# **Richmond Road Upgrade, Marsden Park**

## **Submissions report**

Transport for NSW | November 2024

### 3.4 Change 4 – Updated consideration for flood compensatory storage area

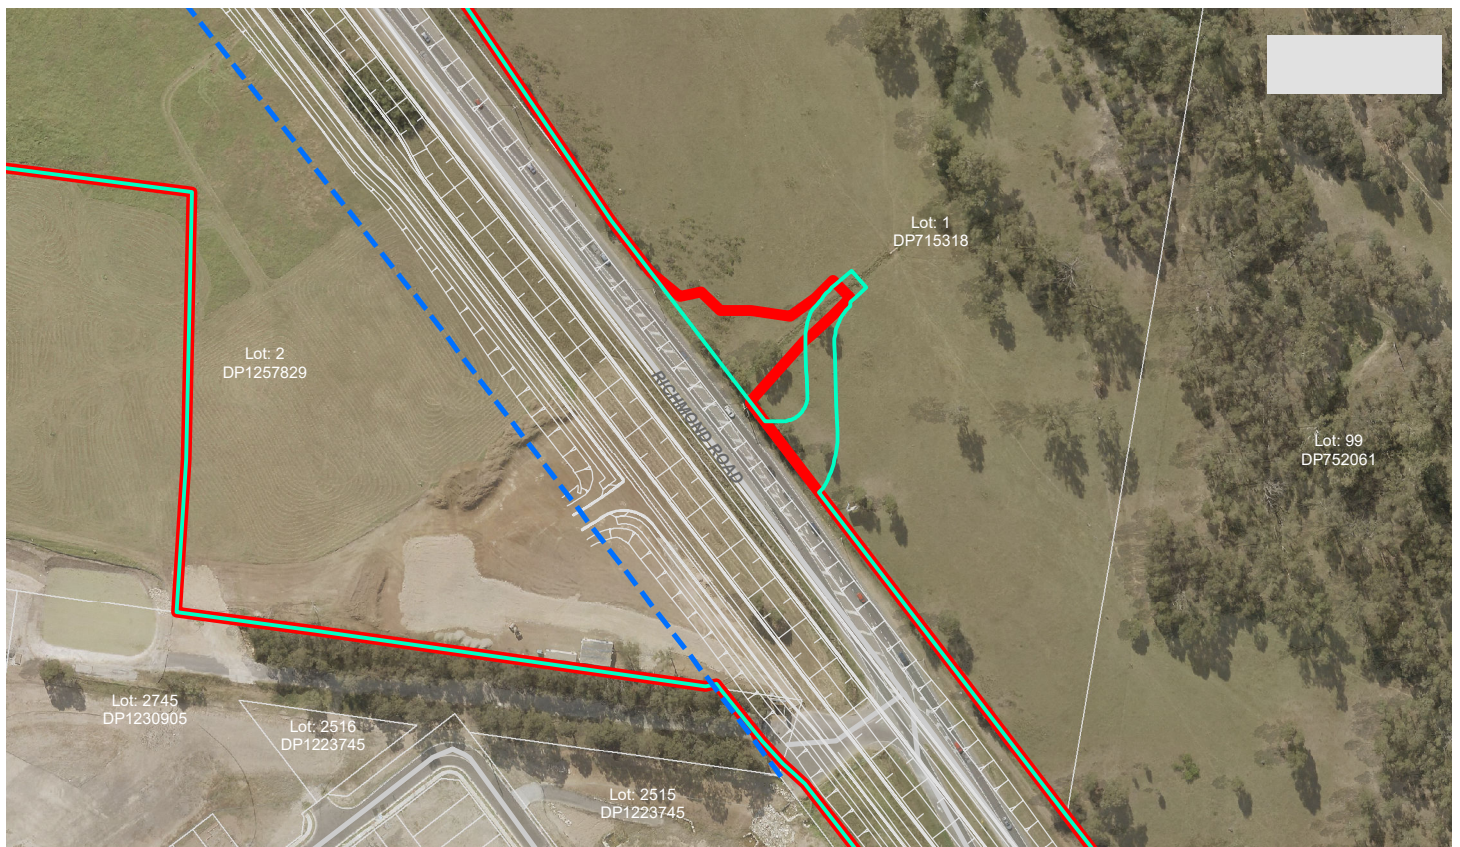
Due to decisions and statements made by the Department of Planning and Environment (DPE) since 2022, an additional assessment of the impacts of Transport projects on flood behaviour in the Hawkesbury-Nepean River Floodplain at Windsor was undertaken by Lyall & Associates in November 2023 on behalf of Transport, in consultation with Blacktown City Council and DPE. The assessment considered the cumulative impact of Transport road upgrades in the area and concluded that the use of flood

compensation storage areas for the proposal would not be warranted. The flood compensation storage area described in the REF will no longer be implemented as part of the project.

**Figure 4.1** Amended drainage culvert footprint

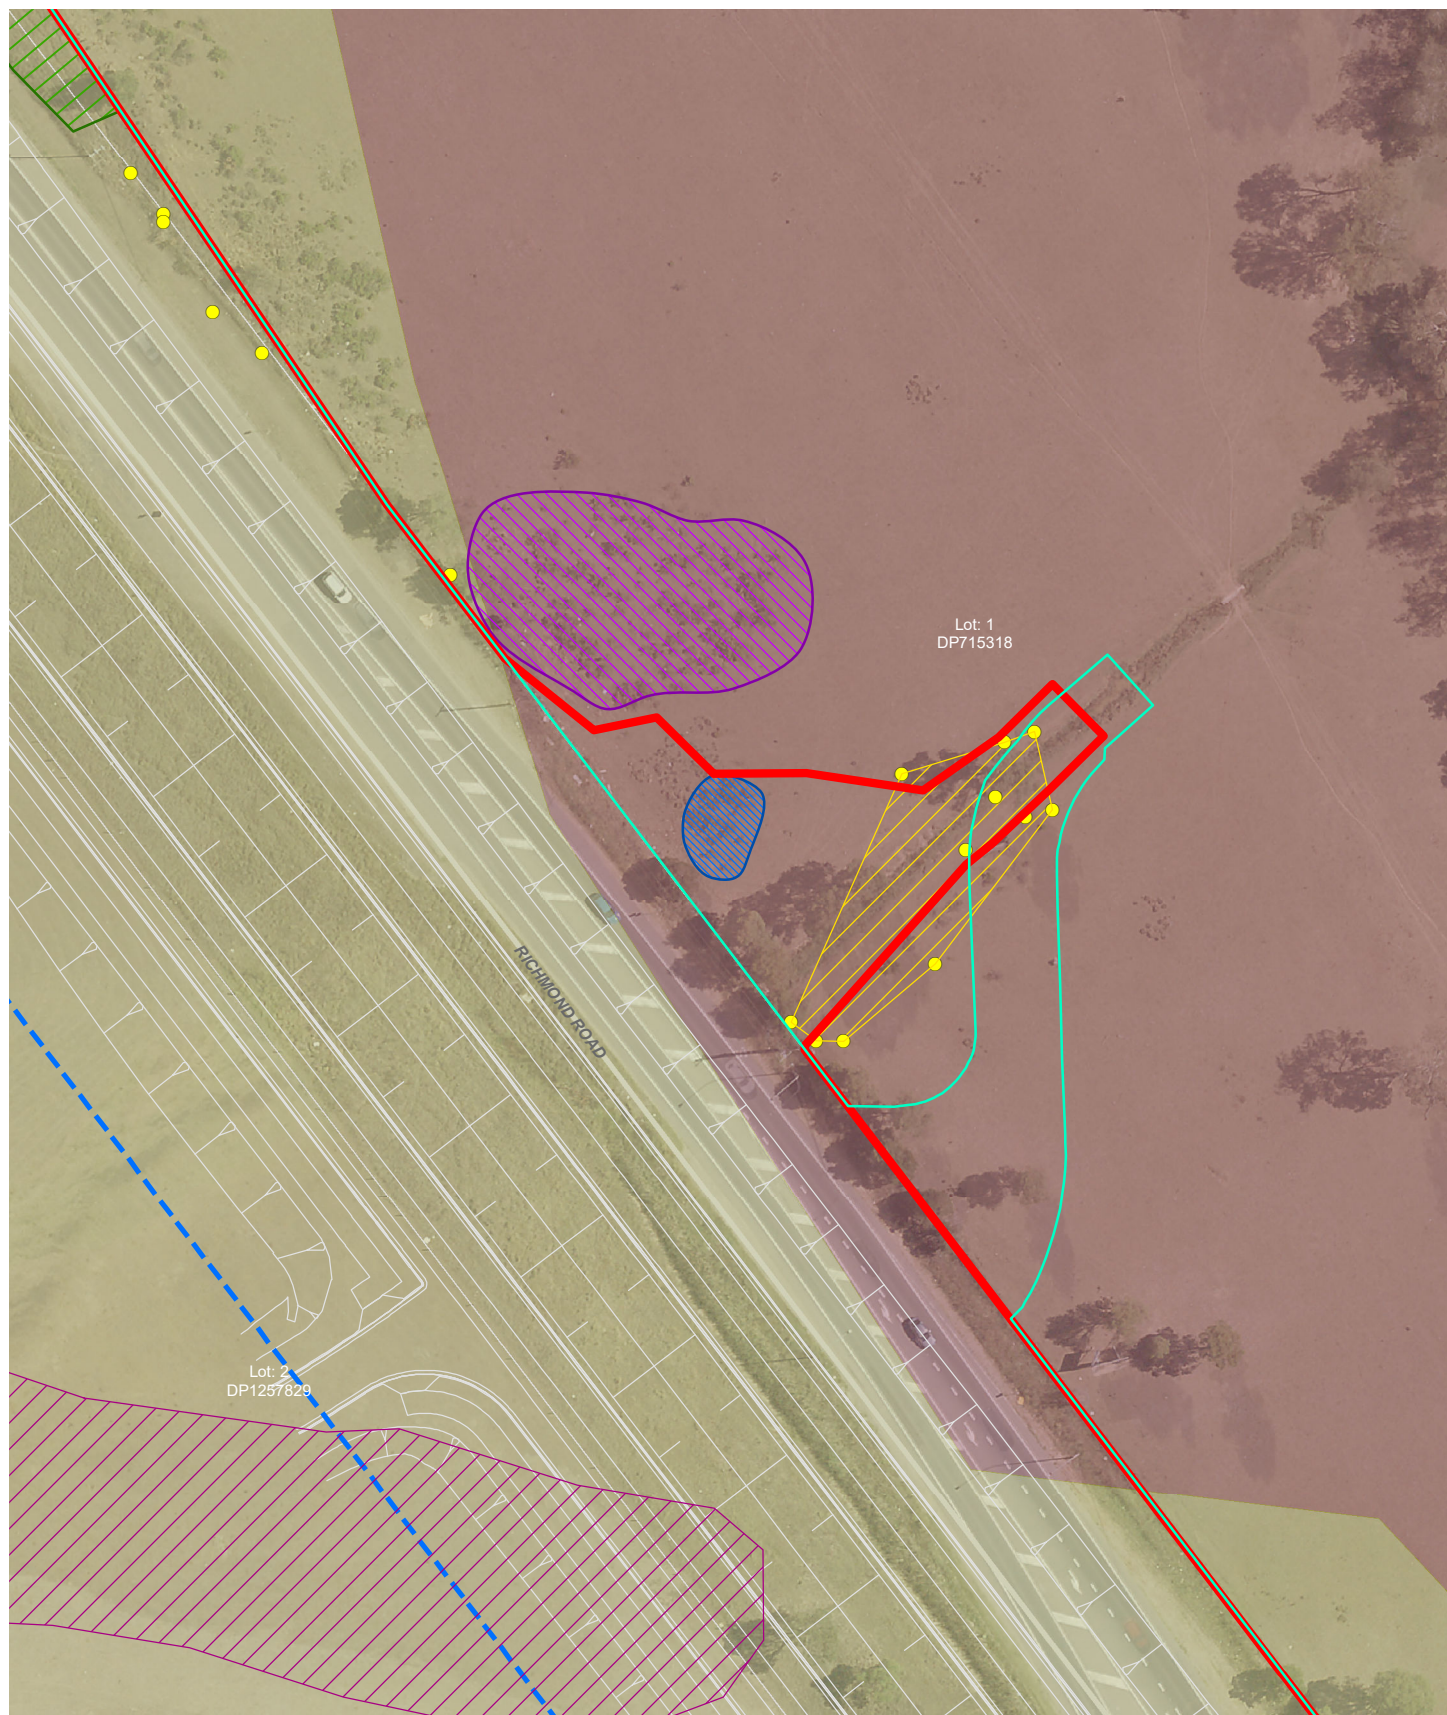
The drainage culvert discharge relocation contains exotic grassland, two *Eucalyptus moluccana*, four *Melaleuca decora* and four *Grevillea juniperina* subsp. *juniperina* individuals. The species composition of exotic grassland in the new area is consistent with that of the previous BAR (Jacobs, 2020). No Plant Community Types are present in the amended portion of the construction footprint. The amended construction footprint does not affect any mapped 'native vegetation' under the Growth Centres SEPP.

During the detailed field inspection undertaken for this amended construction footprint in the culvert drainage area, additional individuals and habitat for *Grevillea juniperina* subsp. *juniperina* were identified in the existing REF construction footprint (shown as yellow hatching in Figure 4-1), increasing the existing proposal impact on this species in non-certified land from 20 to 38 individuals. The proposed amended construction footprint reduces the number of *Grevillea* impacted in non-certified land to four.

Figure 2. Detail of northern upgrade extension provided by Jacobs on behalf of client. Note REF boundary in dark green and proposed changes in cyan

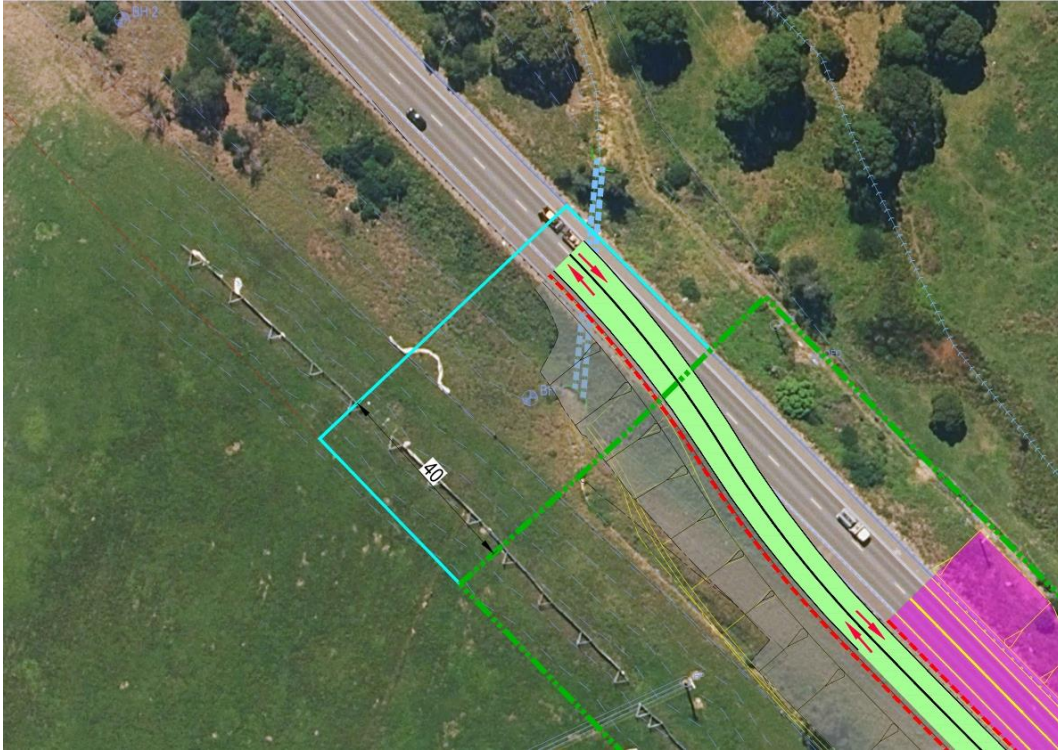
The proposed design change involves a temporary road diversion to facilitate the construction of the proposed southbound carriageway. This design change results in an extension of the northern boundary of the proposed upgrade 40 metres in length and about 26 metres west to the width of the future road reserve (refer Figure 3-1). The works required at the northern extension include:

Figure 3. Detail of Culvert works provided by Jacobs on behalf of client. Note REF boundary in dark green and proposed changes in cyan

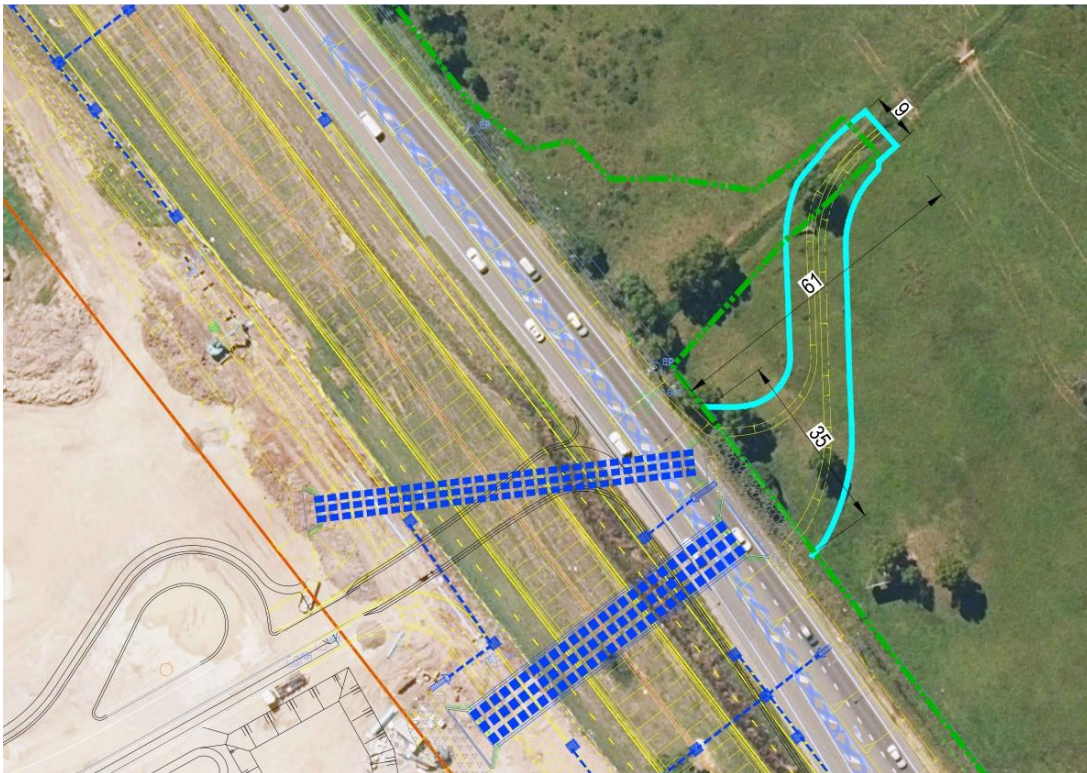
The proposed drainage culvert discharge located east of the roadway has been amended to shift the discharge south about 50 metres to reduce the footprint of impact to land at the downstream end (east side) by combining the two cross-drains from under the road into one discharge point, thereby minimising severance impacts. The alignment reduces the discharge area from 50 metres to 35 metres, further narrowing eastward as shown in Figure 3-1. The proposed works remain as described in the REF and include:
